Project #: PR-2022-007805 (Third Submittal);
SP-2025-00084 Application #: _____

Description: Site Plan Administrative DFT - resubmittal for Pacific Fusion, known a Project Solis.

Re: Project Solis —Tract J Bulk Land Plat for Mesa del Sol Innovation Park II (101605115947920604)
Project No: PR-2022-007805 (Third Submittal); SP-2025-00084
EPC Plan No: FP-2025-00004

On behalf of Project Solis, Stantec Architecture Inc. respectfully submits this supplemental submission of minor design revisions for final DFT review and approval. The proposed substitutions adhere to the preliminary approvals and findings stated in the EPC *Official Notice of Decision*, dated Aug. 21, 2025 (Plan# FP-2025-00004), and remain in full compliance with the City of Albuquerque IDO codes and regulations. The following revisions have been submitted concurrently to Mesa Del Sol ARC for Step II amendment review and approval.

SHEET NAME
ARCHITECTURAL - EXTERIOR ELEVATIONS

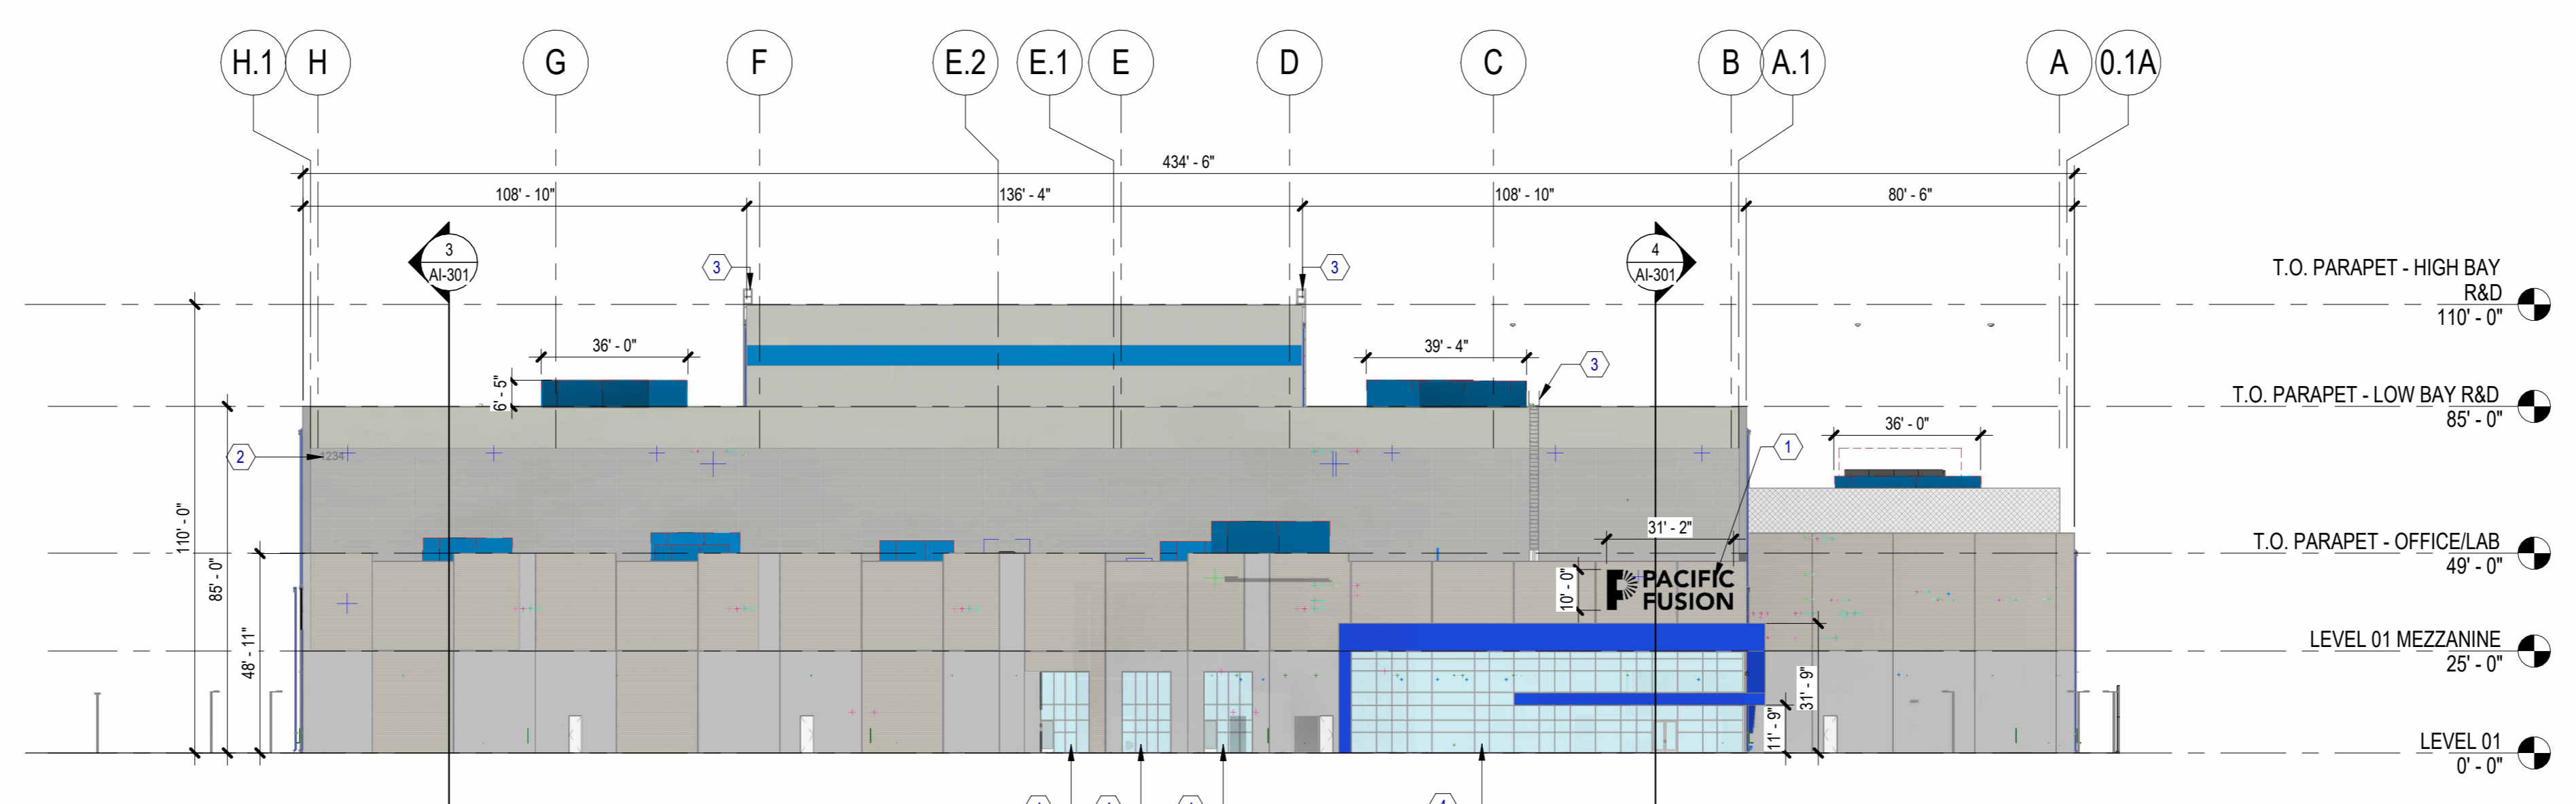
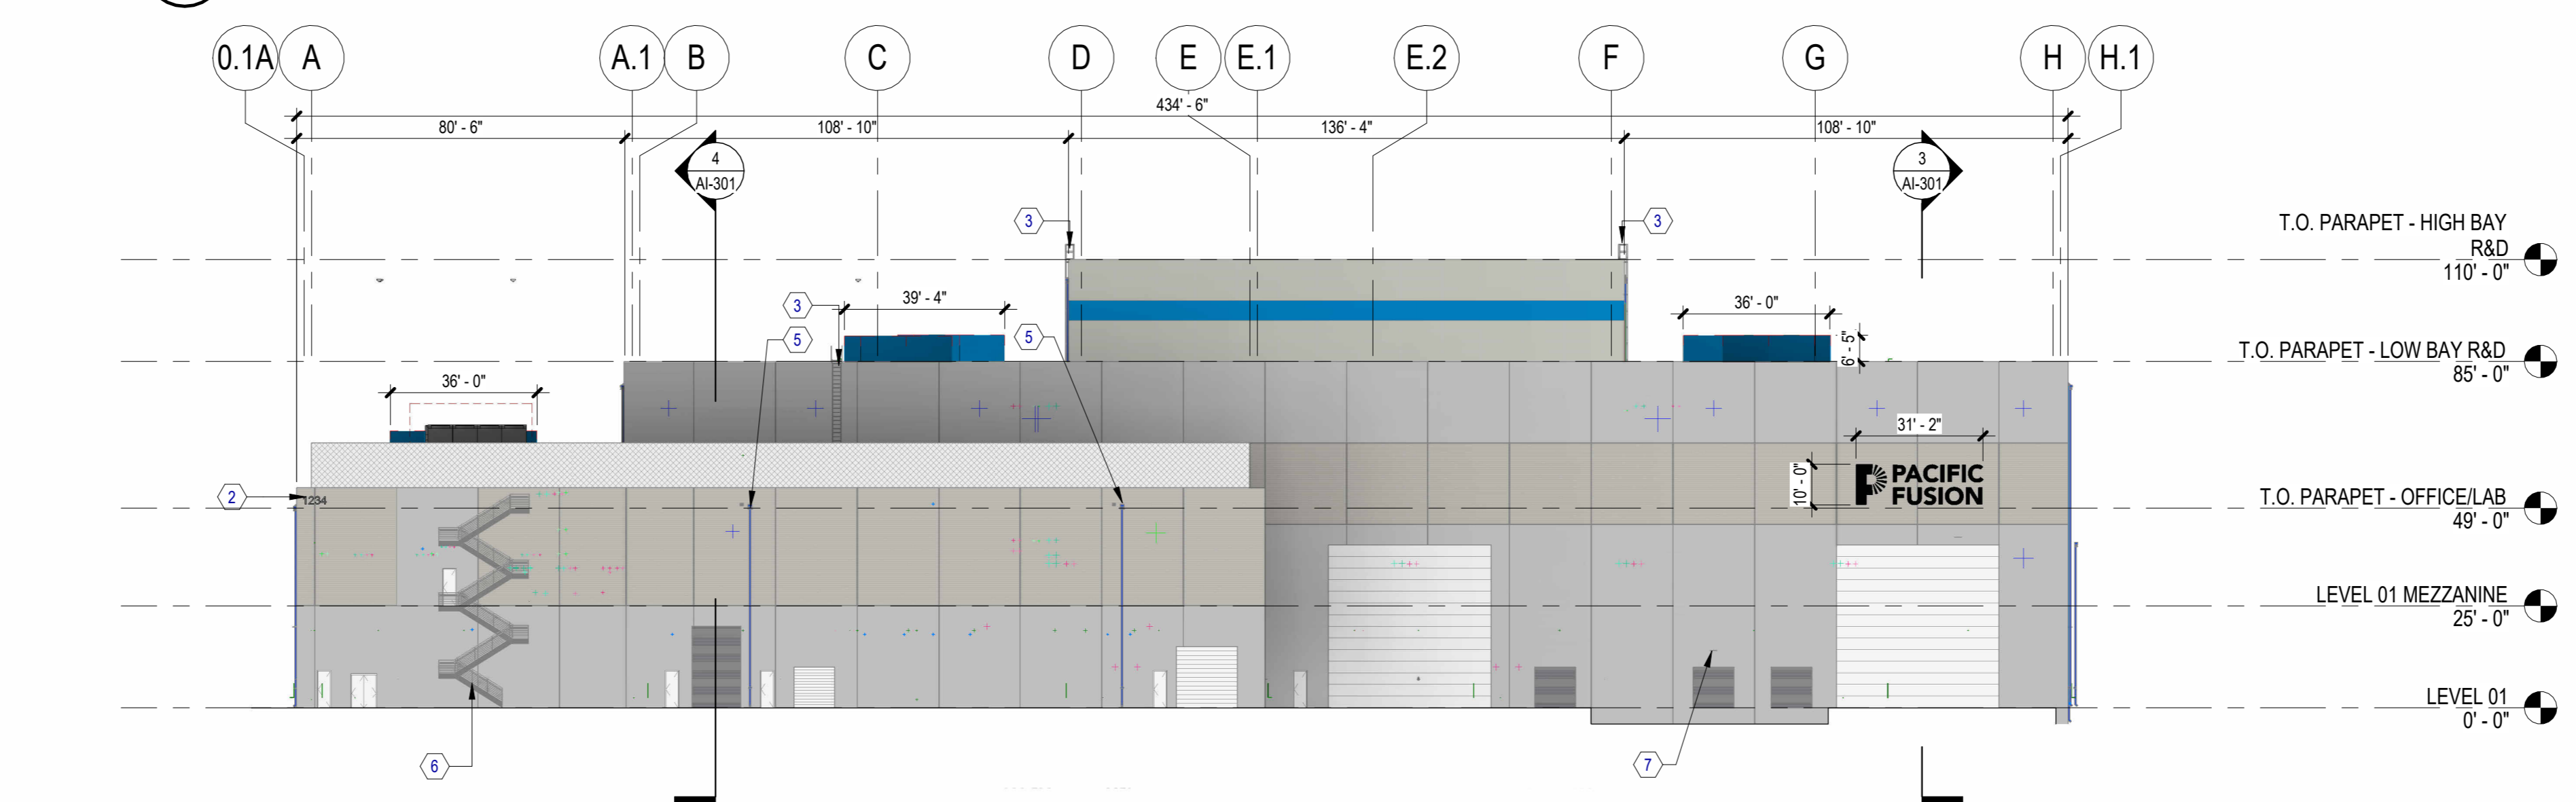
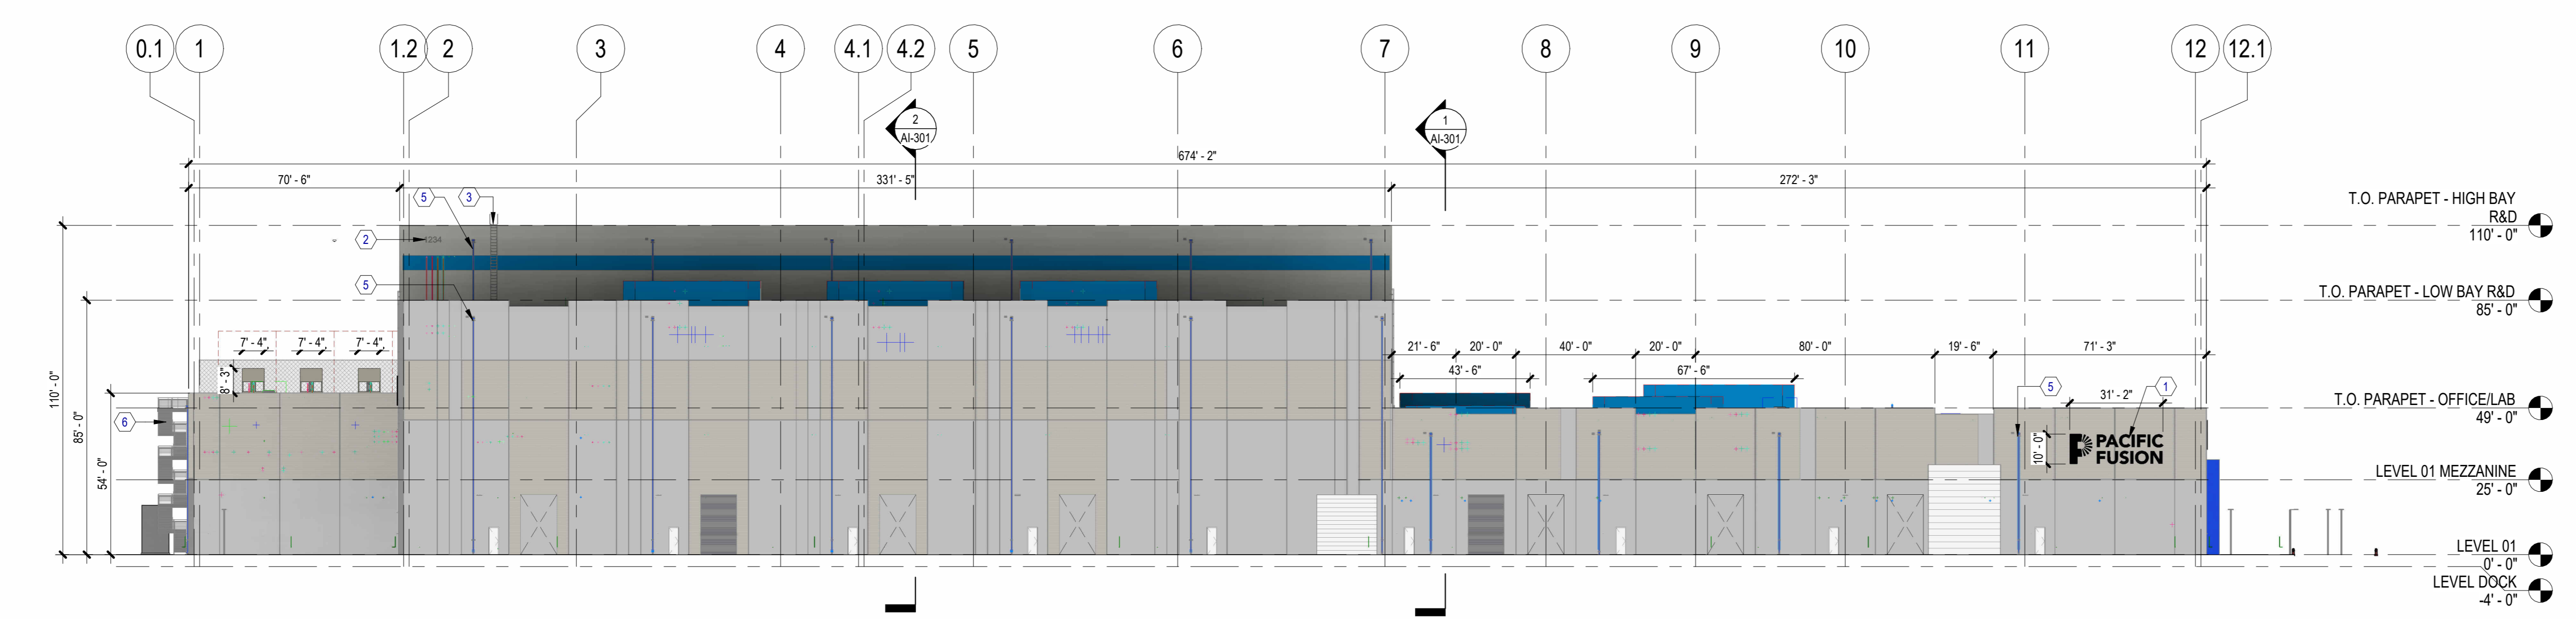
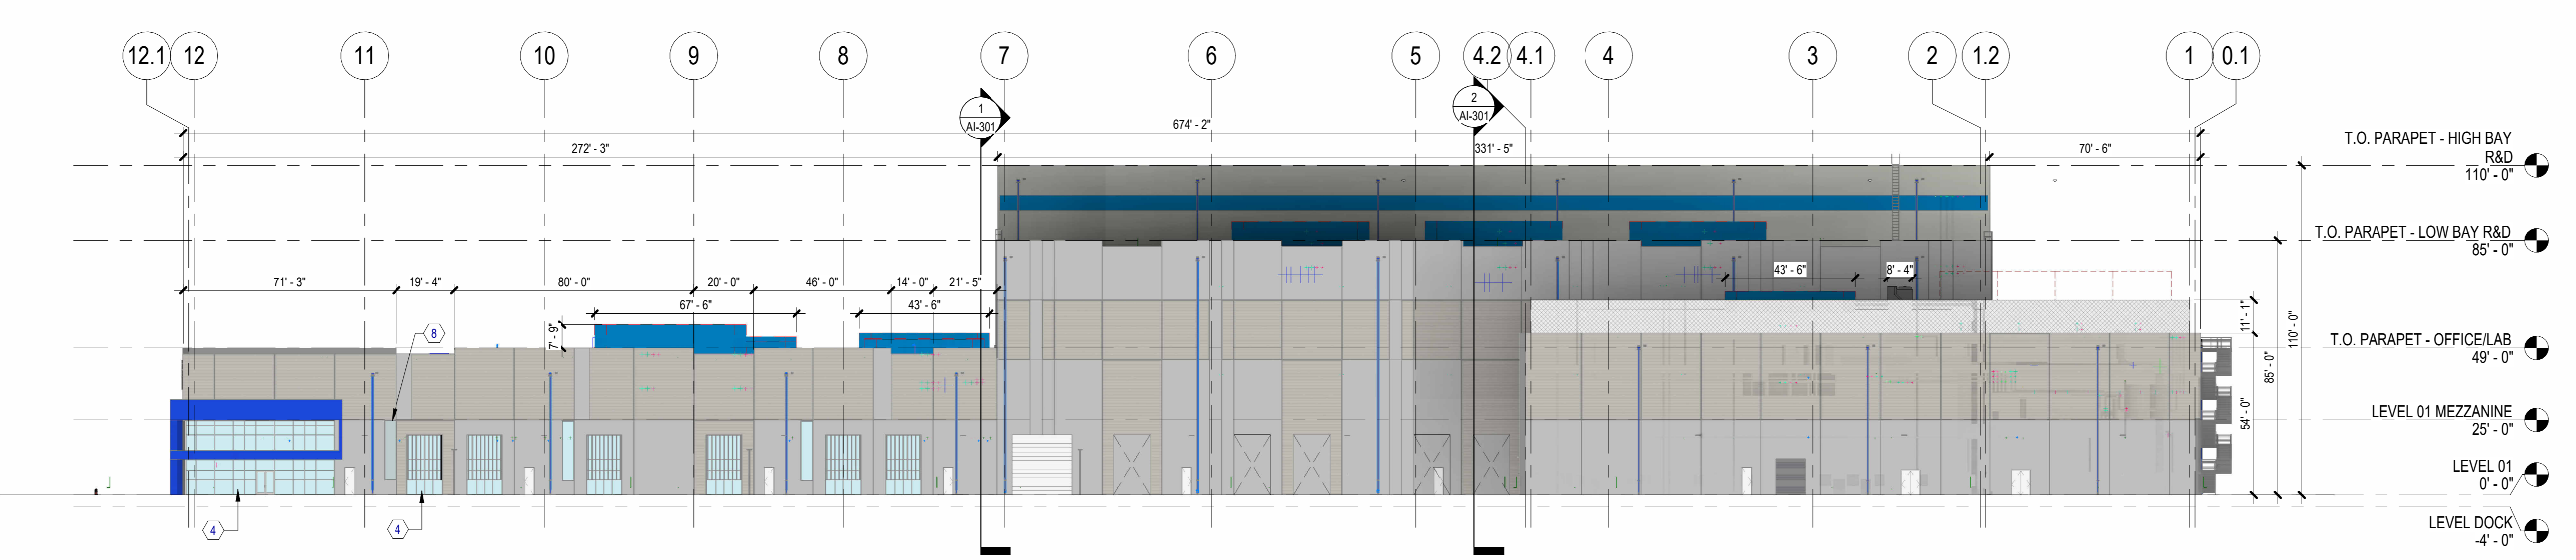
Overall Building – The drawings have been revised to reflect new, relocated or removed openings, including, man doors, overhead doors, and windows. At the high bay, windows have been removed between grids 2 & 7. The revised design remains congruent with the originally approved design, and compliant with all code and zoning requirements.

CUB Facility – The drawings have been revised to reflect the expansion of the CUB facility at the southwest corner of the building, at grid lines A1 thru B4.2. The expansion increases the gross floor area (GFA) from 225,795 sf. to 239,464 sf. a (6% increase). The height of the CUB facility walls also increased from 45' to 54', and equipment screening has been added around the perimeter of the CUB roof to screen rooftop equipment.

SHEET NAME
 ELECTRICAL PHOTOMETRICS SITE
 PLAN

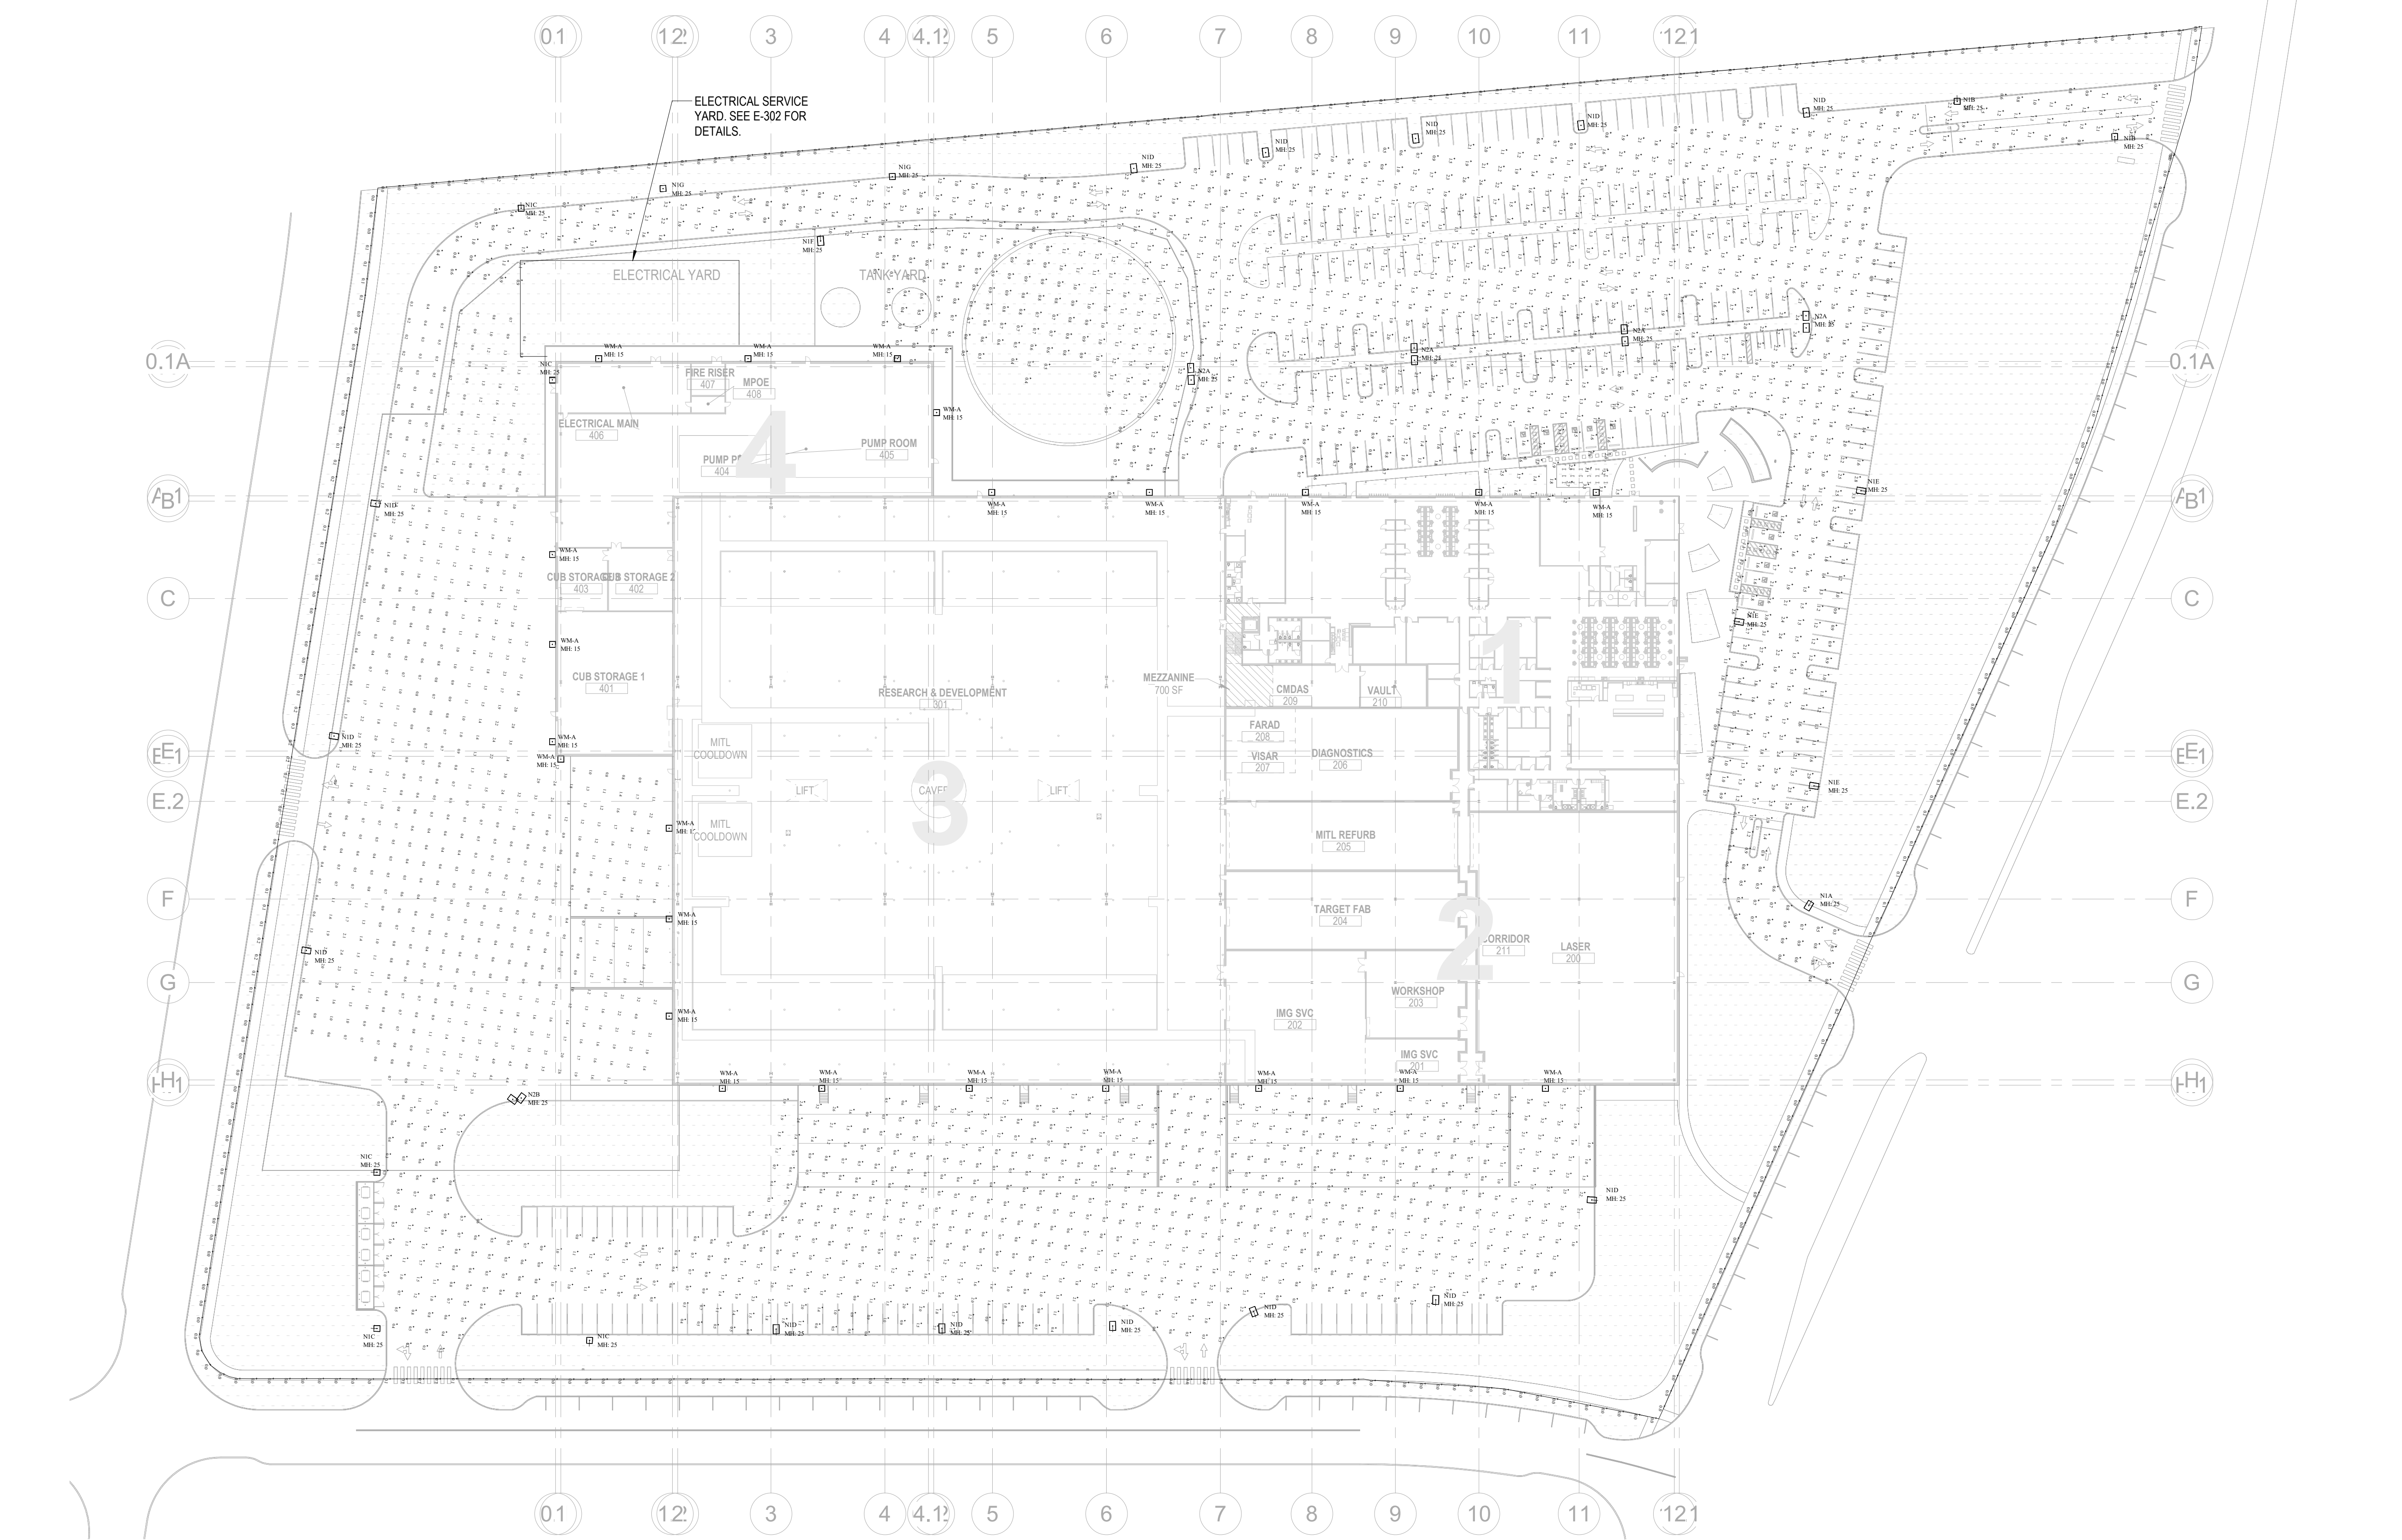
Site Lighting – The site lighting has been adjusted to match the minor modifications to the overall site design.
